re: **Site Servicing Plan Review**
Proposed Self Storage Development
75 Michael Cowpland Drive – Ottawa, Ontario

file: PG3798-MEMO.02 Revision 1

Site Servicing Plan Review

Figure 1 - Typical Rigid Insulation Detail

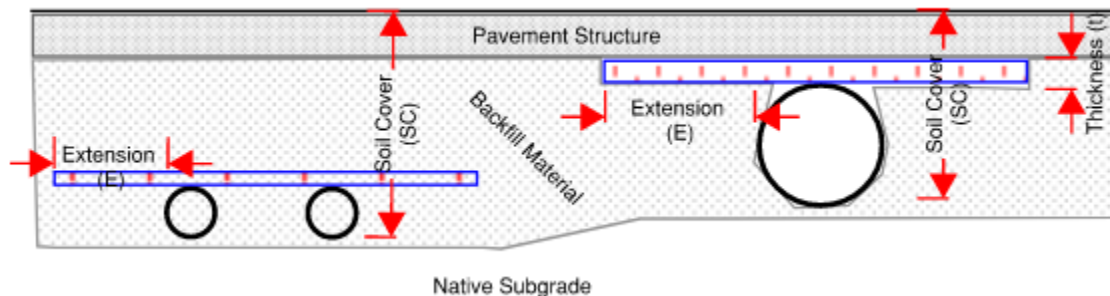
It should be noted that the existing shallow services pipes along the north corner of the site will be subject to insulation due to the new proposed grading at the subject site. Depending on the soil cover above the invert level of the pipes, the following table indicates the minimum thickness of rigid insulation required to be placed directly above the obvert of the subject pipes. A minimum HI-40 rigid insulation panels should be placed directly above the existing pipes and should extend horizontally beyond the edges of the subject pipes as shown on *Figure 1 – Typical Rigid Insulation Detail* below.

The recommended rigid insulation thicknesses based on the available soil cover are shown in Table 1 below.

Table 1 - Rigid Insulation Recommendations for Storm Sewer Pipes with Reduced Soil Cover			
Thermal Condition	Soil Cover Provided (mm)	Insulation Dimensions	
		Thickness (mm)	Extension (mm)
Unheated	600 to 900	125	Extend 1200 mm horizontally beyond edge face of the sewer
	900 to 1200	100	Extend 1200 mm horizontally beyond edge face of the sewer
	1200 to 1500	75	Extend 900 mm horizontally beyond edge face of the sewer
	1500 to 1800	50	Extend 600 mm horizontally beyond edge face of the sewer
	1800 to <2100	25	Extend 300 mm horizontally beyond edge face of the sewer

All rigid insulation should consist of either Dow Chemical High-Load 40 (HI-40) or equivalent other approved by Paterson. The placement of all insulation within the service trenches must be reviewed and approved by Paterson personnel at the time of construction.

PG3798-MEMO.02 REVISION 1 - FIGURE 1 - THICKENED-EDGE SLAB INSULATION DETAILS AND PLAN

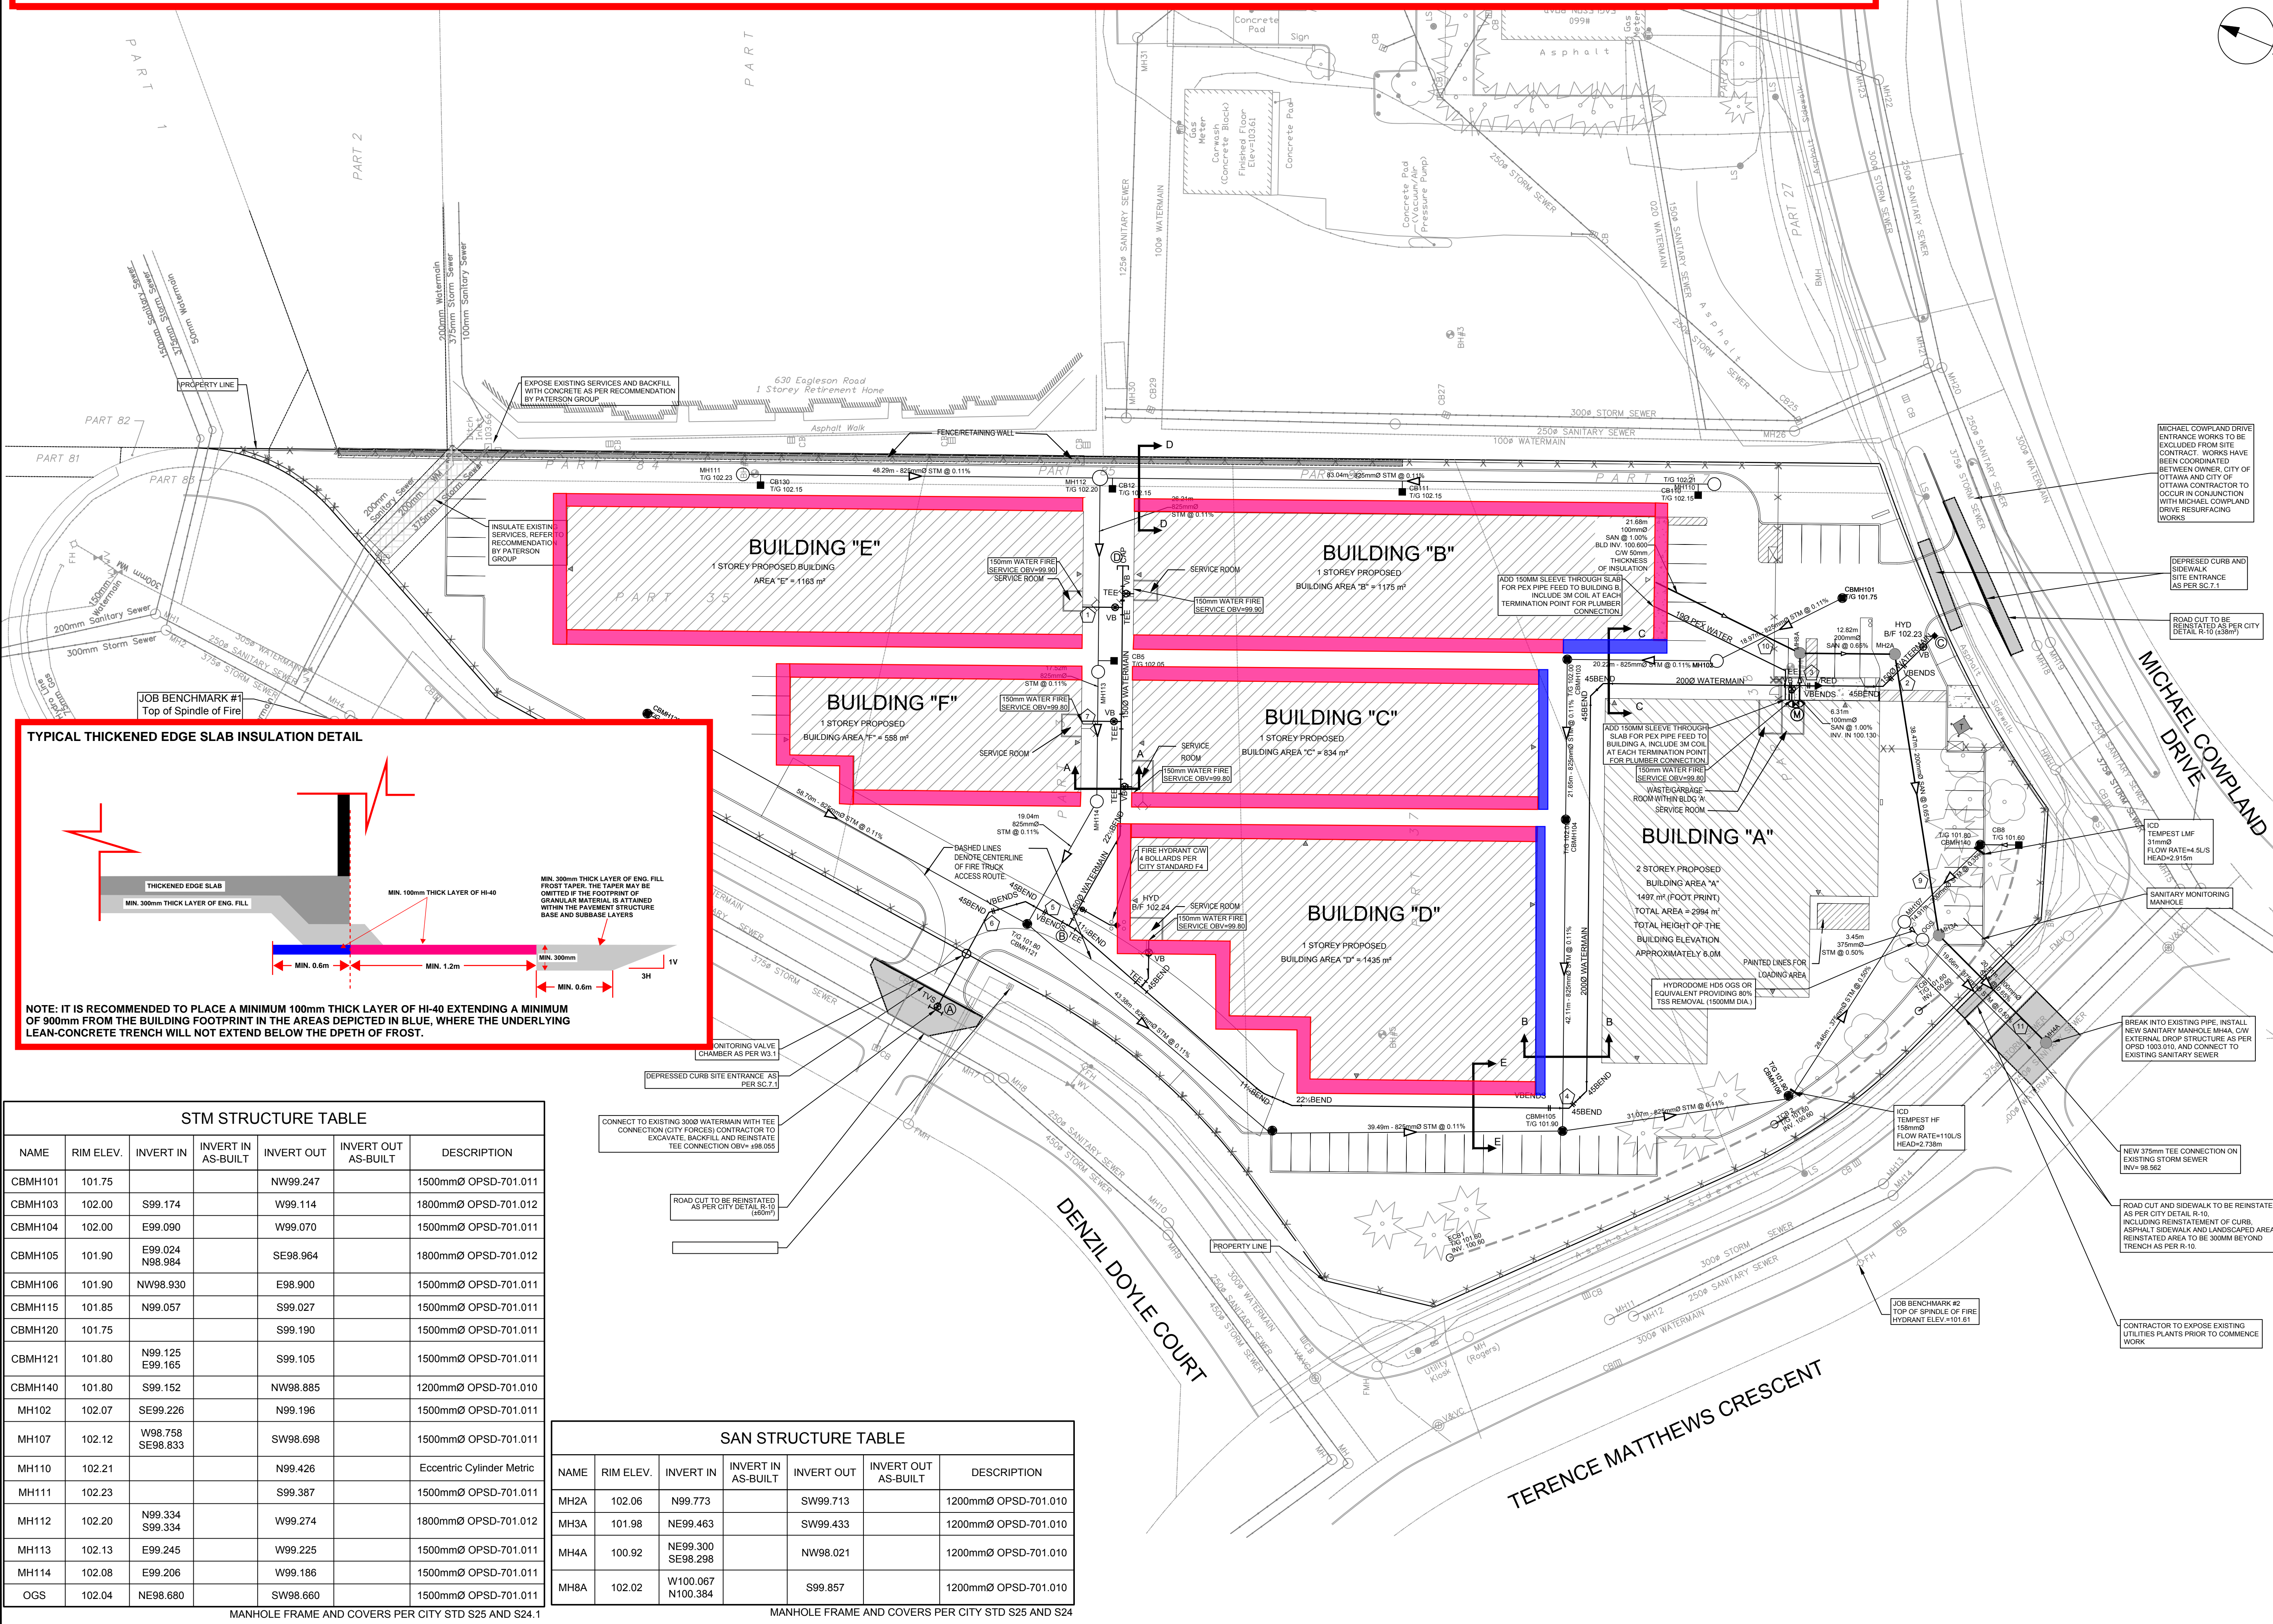
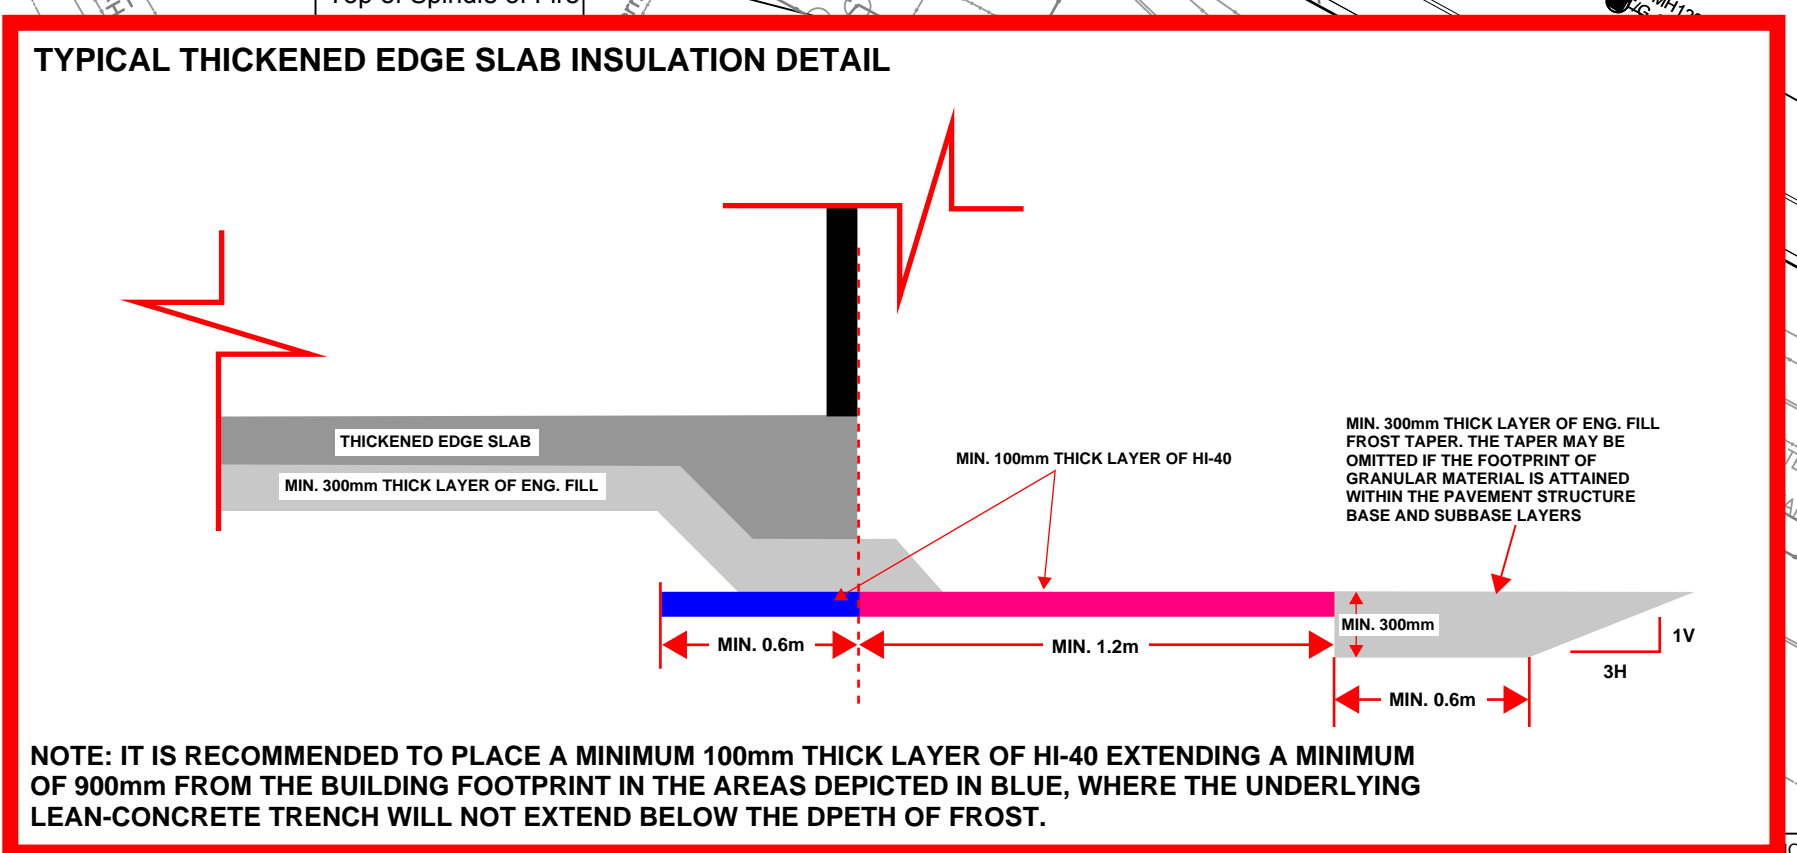
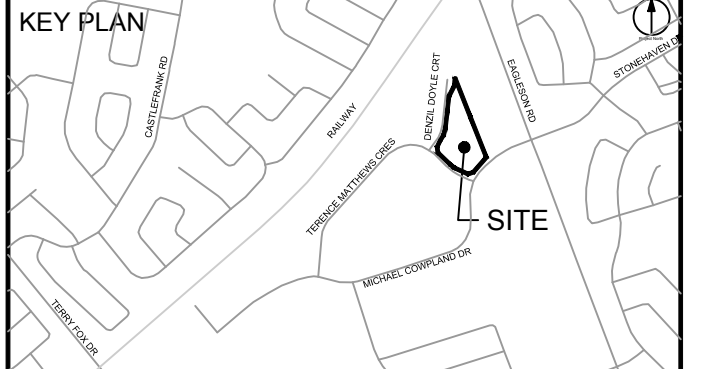
It is recommended the near-vertical trenches extend a minimum of 150 mm horizontally beyond the overlying footing footprint. Based on our review, the lean-concrete trench detail has been incorporated satisfactorily into the above-noted site servicing plans with the exception of widening the trench a minimum of 150 mm beyond the face of the overlying thickened edge footing footprint.

Where the lean-concrete trenches will terminate within the frost zone for a heated building, it is recommended to extend a minimum 100 mm thick layer of HI-40 rigid insulation a minimum horizontal distance of 900 mm beyond the overlying building footprint. The location of this insulation is depicted in blue on *Figure 1 – Thickened Edge Slab Insulation Details and Plan* attached to this memorandum. Where the lean-concrete trench is anticipated to extend below frost zone for a heated building, the exterior building insulation has been omitted from the above-noted plan.

The placement of the lean-concrete trench and rigid insulation should be reviewed and approved by Paterson personnel at the time of construction.
